FINDINGS OF FACT AND CONCLUSIONS OF LAW

RE: PETITION FOR SPECIAL HEARING
515' W of the c/l intersection of Old Court Road & Woodholme Avenue
(4020 Old Court Road)
3rd Election District - 2nd Councilmanic District
David M. Paige, et ux - Petitioners
Case No. 93-188-SPH

TO: Arnold Jablon, Director DATE: December 18, 1992
Zoning Administration and Development Management
FROM: Robert W. Bowling, P.E., Chief
Developers Engineering Division
RE: Zoning Advisory Committee Meeting
for December 21, 1992
Item No. 194

RE: Paige Property
Final Development Plan Hearing
February 23, 1993

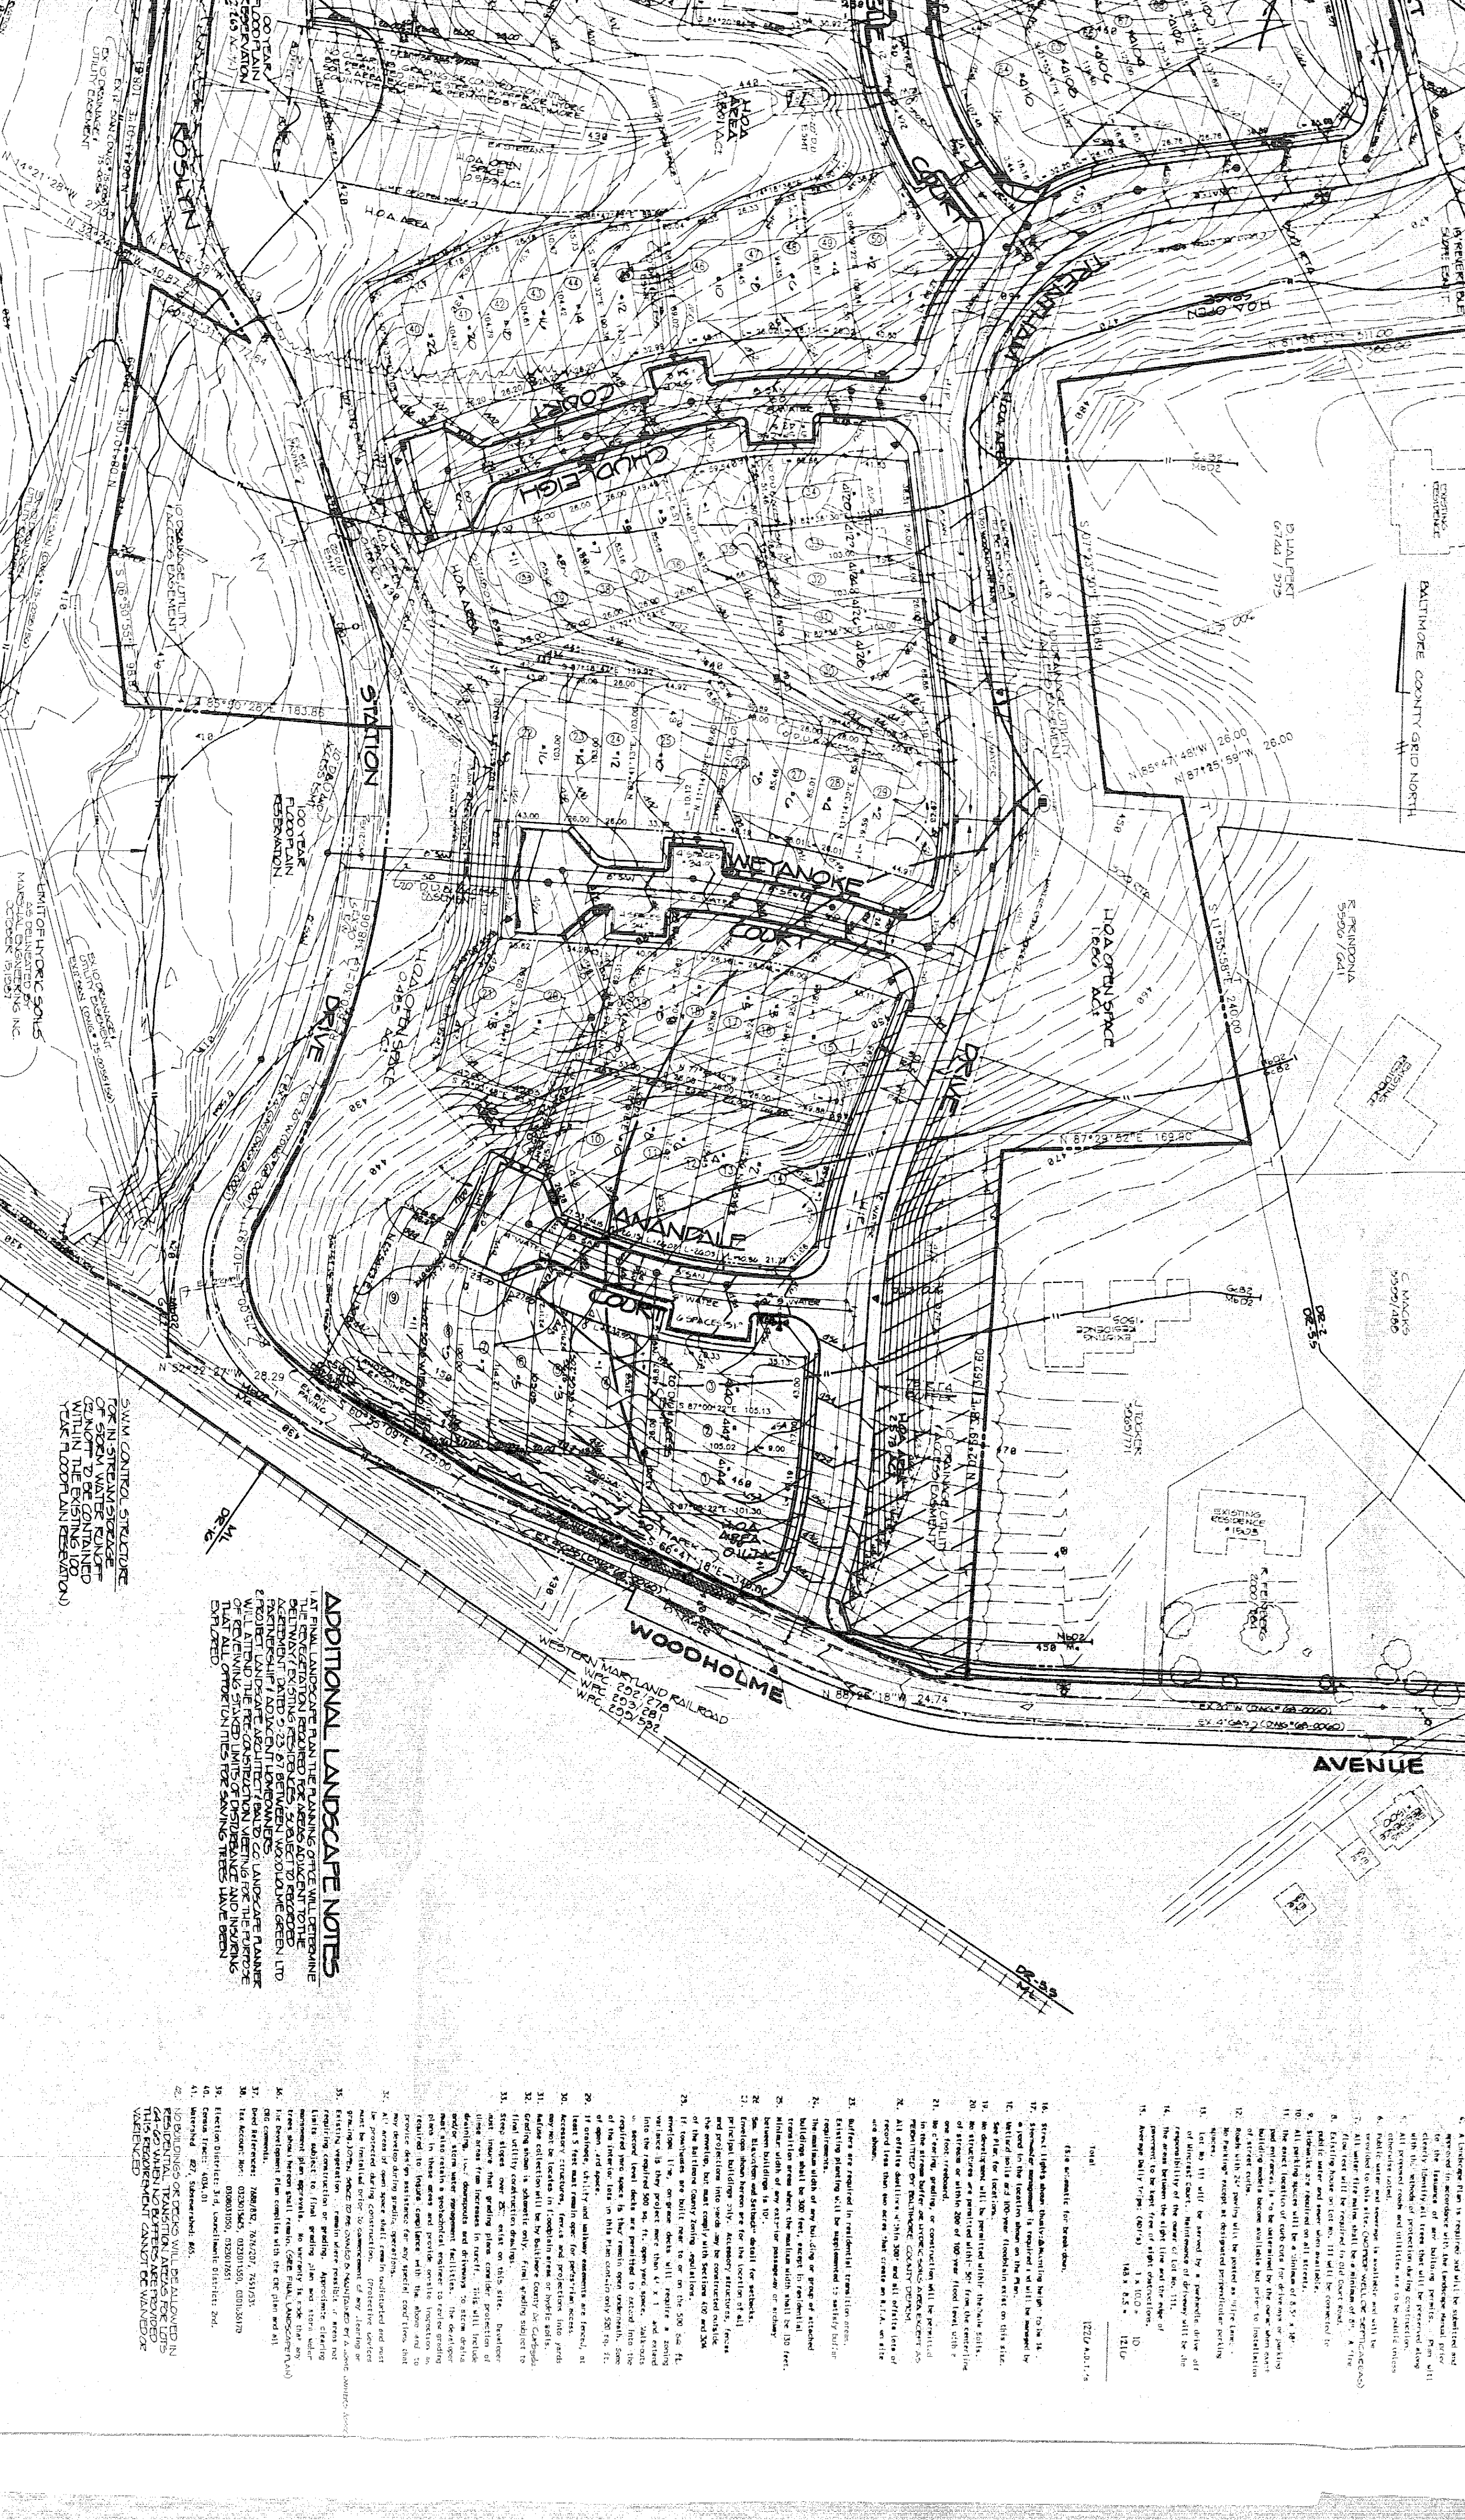
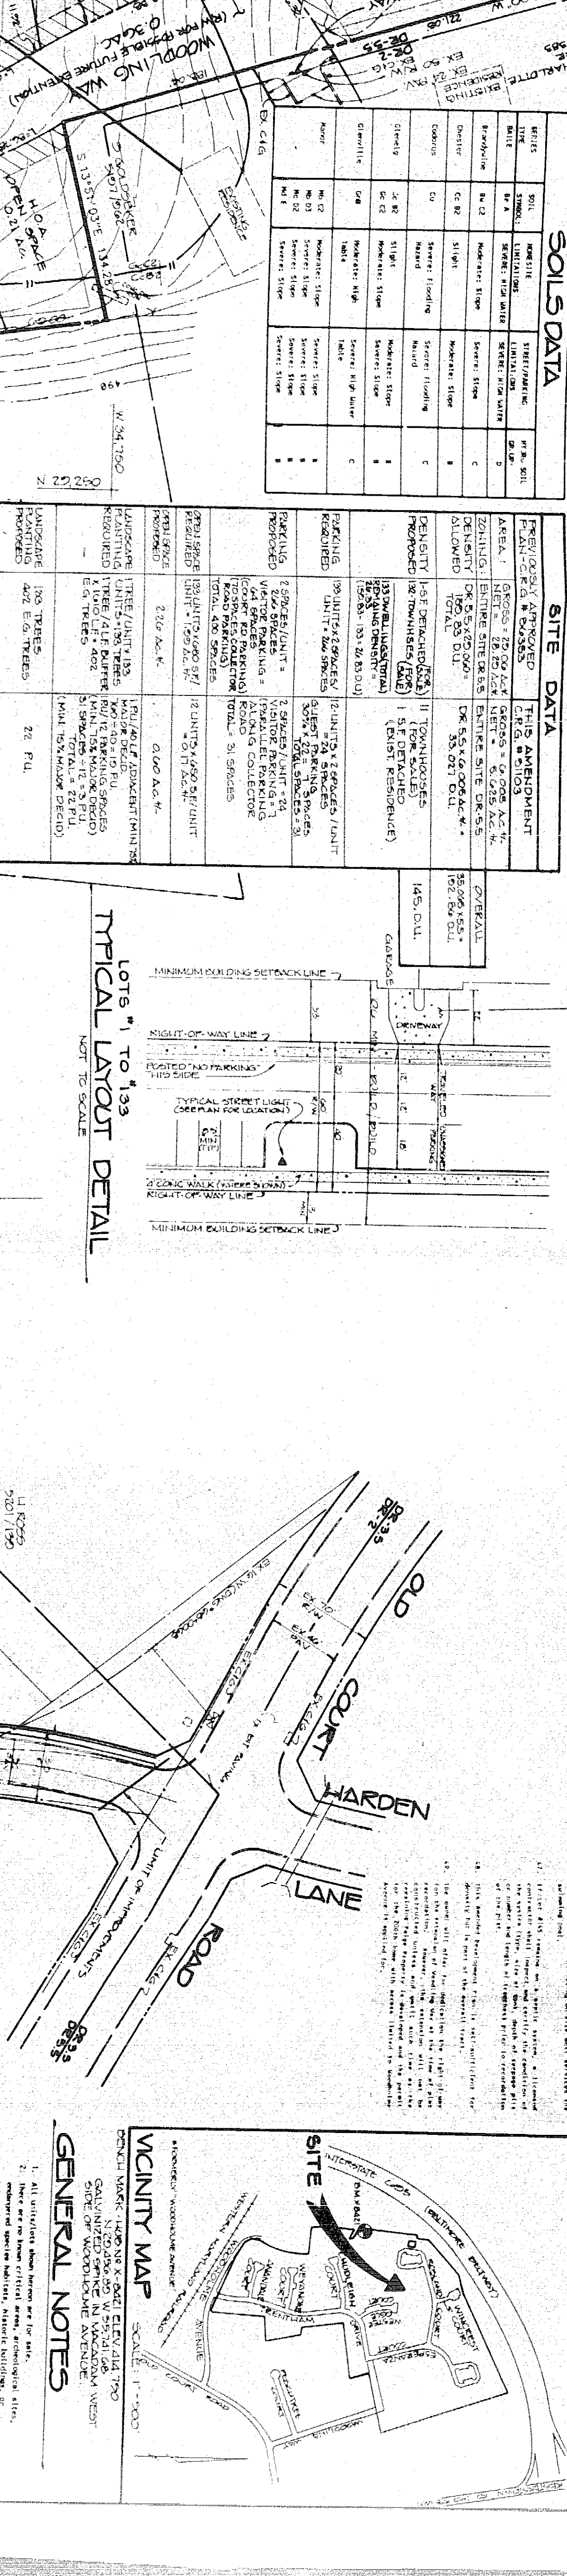
1. The CRG Plan shows four guest parking spaces located in the "island" of Esperanza Court directly opposite the townhouses to be built. This plan shows the same four spaces as parallel parking on the inside of a curve where the pavement is narrowing from 30 feet to 24 feet. This is an unsafe location and should not be approved.

2. CRG comments state that the right-of-way for the Woodling Way connector road shall be 50 feet wide. This plan does not provide the whole 50 feet. Also, revertible slope easements must be provided. Since they will encumber the H.O.A. Open Space, the easements should be shown on this plan.

3. Public Works policy on access is that, when there are more than 100 dwelling units proposed, a second means of access must be proposed and must be feasible. The Woodling Way connector road is proposed as the second means of access, but the alignment shown does not appear to be feasible because of the grade difference between the end of Woodling Way and the proposed intersection with Esperanza Court. The connector road cannot be built to County standards as proposed and therefore this plan should not be approved. Furthermore, the CRG plan should be revised to show a proposed second means of access that is feasible.

Four (4) guest parking spaces on the inside corner of Esperanza Court. Mr. Bowling believes that the location on the inside of the curb is "unsafe" because "the pavement is narrowing from 30 feet to 24 feet." In the area of the four proposed spaces, the paving width is never less than 30 feet, although the road does taper to 24 feet beyond the area of the spaces.

Mr. Bowling wishes the Woodling Way connector to be 50 feet wide and for us to provide revertible slope easements. We will provide a plan for your approval that shows the Woodling Way extension a minimum of 50 feet wide with revertible slope easements.

Mr. Bowling does not believe that the grade difference between Woodling Way and Esperanza Court meets County standards. This second means of access has been previously approved on at least five (5) prior plans. Notwithstanding that, our office confirmed that the connection of Woodling Way and Esperanza Court is feasible. The grade on the Paige property at the end of Woodling Way is approximately 487. The grade at the corner of Trentham Drive and Esperanza Court is approximately 465. Dividing by the distance required to connect the two roads (approximately 307 feet), yields a grade of roughly seven percent (7%), which is within Baltimore County standards.
